AGENDA
City of Salmon Arm
Development and Planning Services
Committee

Subject: Development Permit Application No. 444 (Form and Character)
 Legal: Lots 1 and 2, Section 6, Township 21, Range 9, W6M, KDYD, Plan 3538
 Civic Address: 4400 & 4600 Canoe Beach Drive NE
 Owner/Applicant: BDGA Development Company Inc. No. 1283548 (David Claeys)

SUBJECT: Development Variance Permit Application No. VP-556
 Legal: Lots 1 and 2, Section 24, Township 20, Range 10, W6M, KDYD, Plan EPP121728
 Civic Address: 2790 20 Avenue NE
 Owner: 1348074 BC Ltd. And R. & E. Meise
 Agent: Franklin Engineering (Jason Wickner)

SUBJECT: Development Variance Permit Application No. VP-550 (Servicing)
 Legal: Lot A, Section 11, Township 20, Range 10, W6M, KDYD, Plan 11982
 Civic Address: 1681 10 Street SE
 Owner: NTL Dev. Ltd.
 Agent: Franklin Engineering Ltd. (Jason Wickner)

OVERALL SITE PLAN 1:500

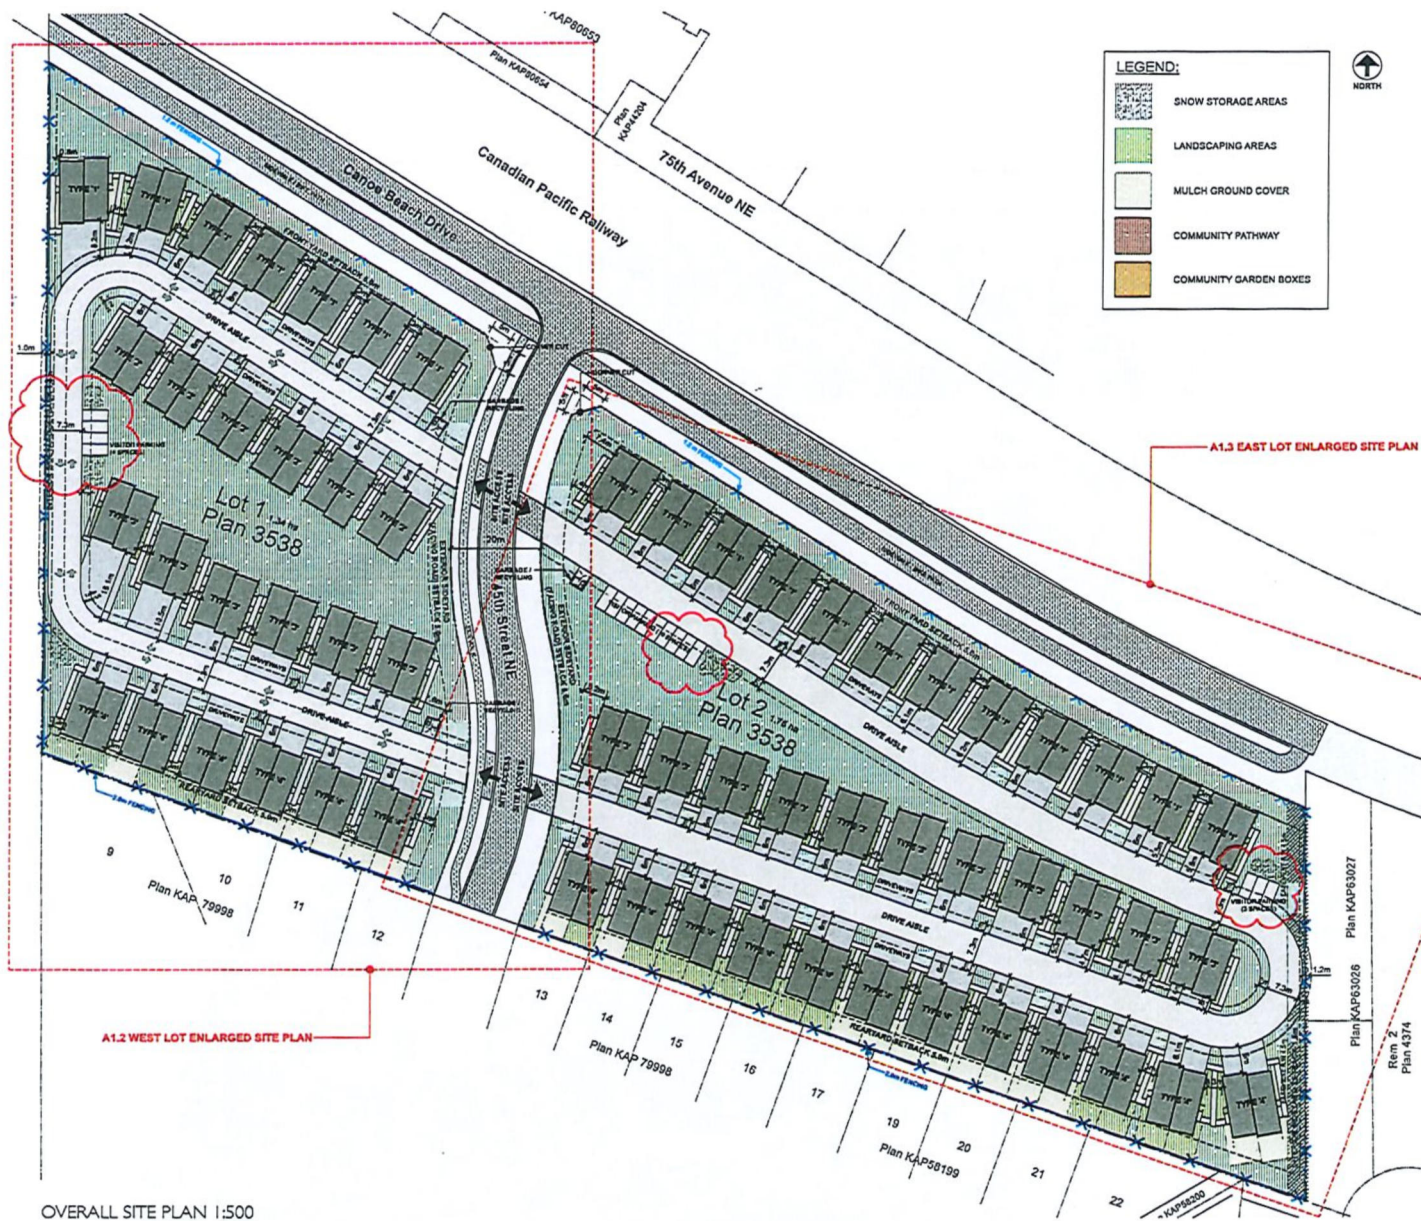
Note:
Landscape Plan to be revised to reflect Site Plan (additional visitor parking, snow storage areas and mail/delivery kiosk. Common garbage/recycling areas to be removed)
